**Town of Rotterdam
Planning Commission
February 4, 2025**

1. **Stewarts Shops Corp – Highbridge Road.** Final Site Plan/Special Use Permit Public Hearing for the construction of a ±3,975 square foot Stewarts with three (3) fueling islands on a consolidated ±1.86-acre parcel. Engineer: Scott Edward Kitchner PE.

In response to the January 15, 2025 letter from Ryan Trunko, PE of Greenman-Pedersen, Inc., we offer the responses below in *red*:

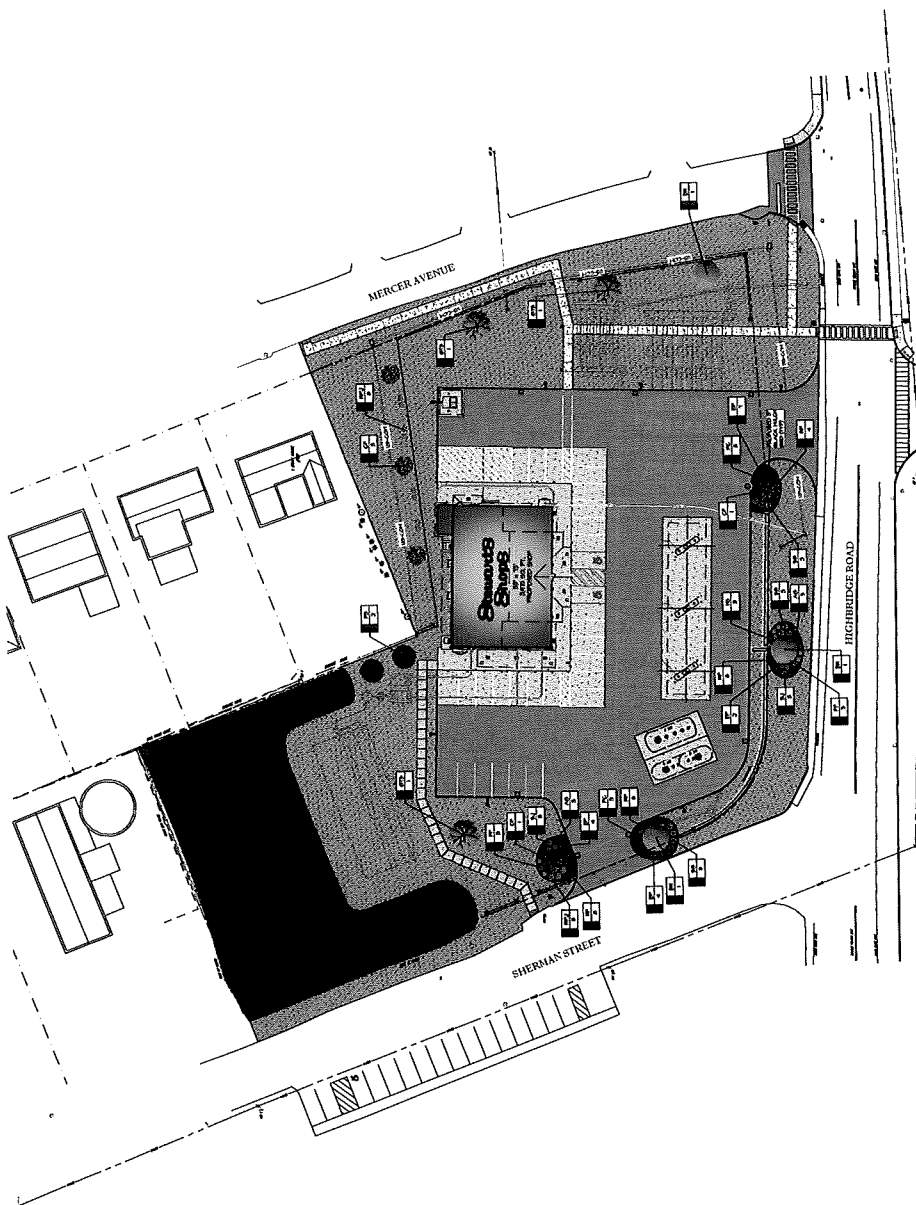
1. The applicant has provided a "Welcome to Highbridge" signage and wall detail for consideration. The Planning Board should review the signage for aesthetics.

2. Scales should be provided on the cover sheet for each of the elevations and signs that are detailed.

3. The address of the proposed Stewart's on the cover sheet is shown as 1098, while the site address of 1100 has been established in other submitted documents. Please update the coversheet to reflect the 1100 address.

Comment noted.

The address on the Title Sheet has been updated.

A signature space has been added to the Title Sheet of the Site Development Plans.
